Saga 43 Cut up and Cut back update
4-8-19

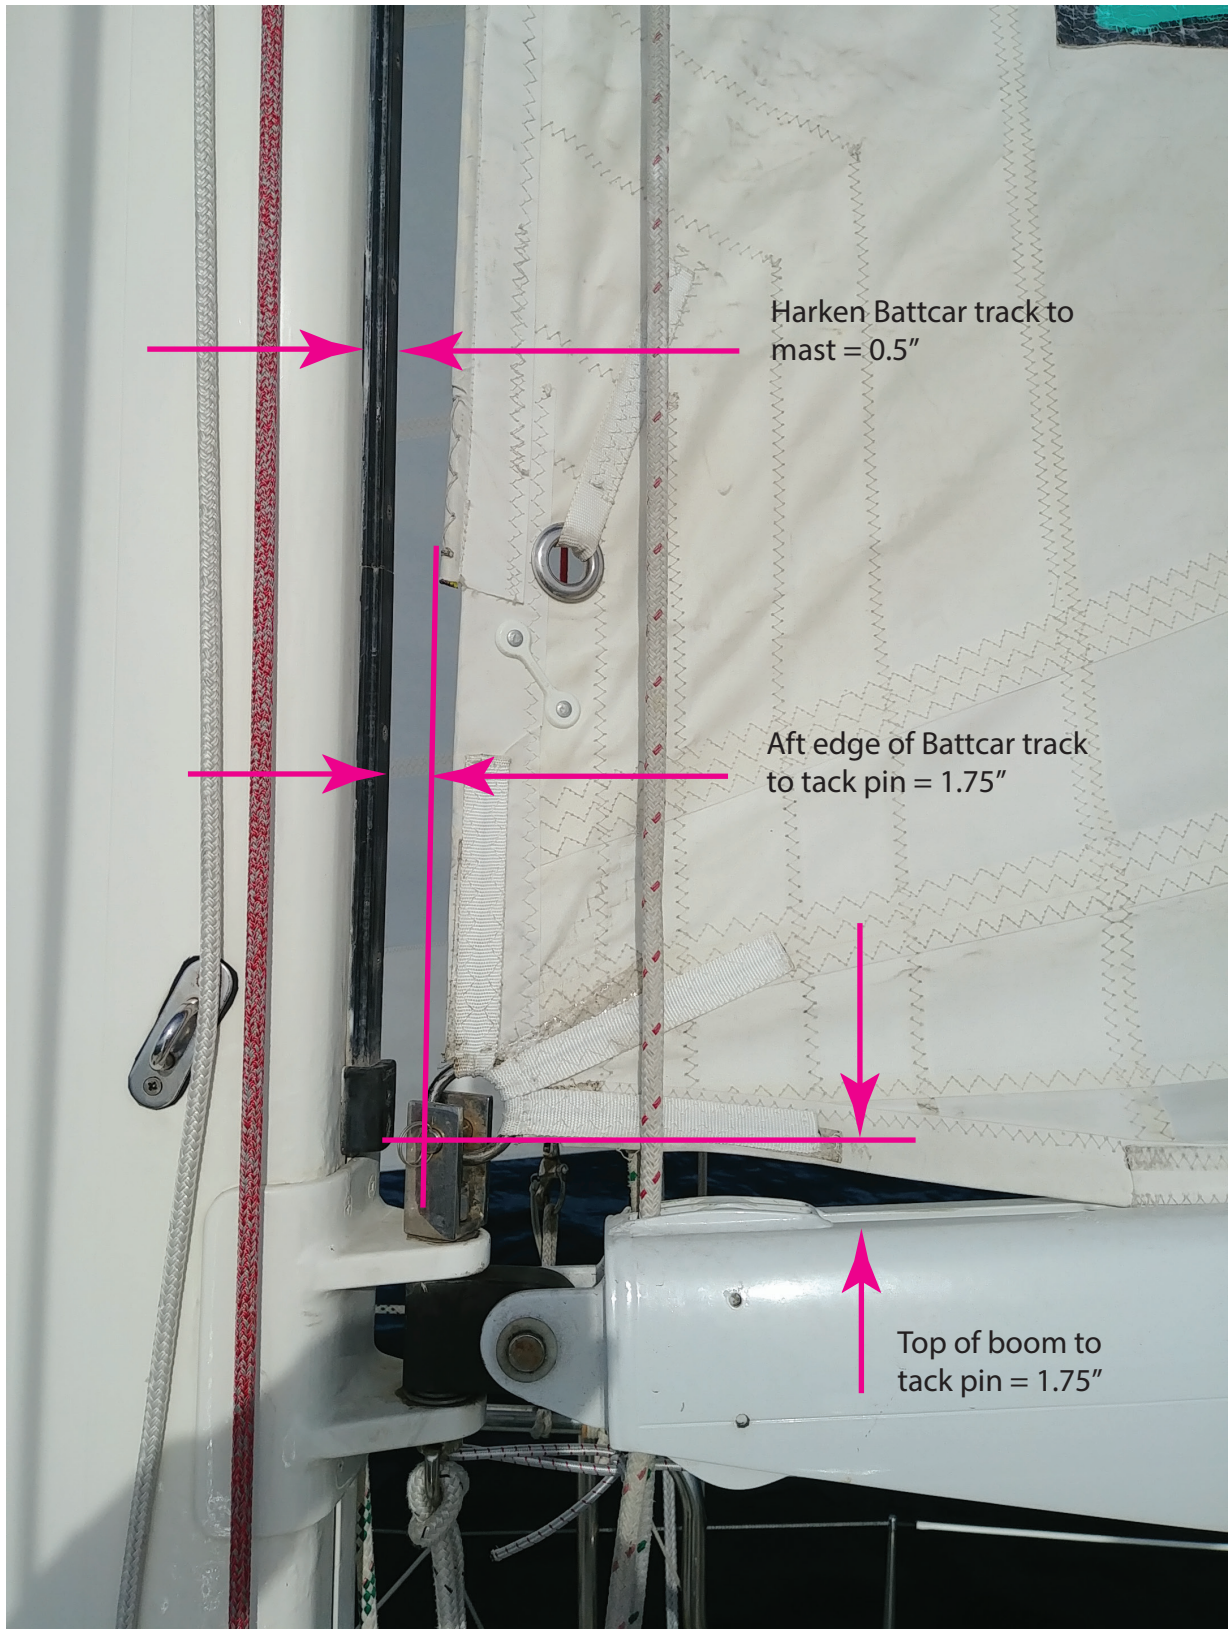
Cutback related dimension regarding luff attachment to Battcar track:

Note that when batten end swivels and intermediate cylinders are attached to the luff, the pin locations should all line up, and this line = 1.0" from after edge of battcar track = 1.5" from aft edge of mast.
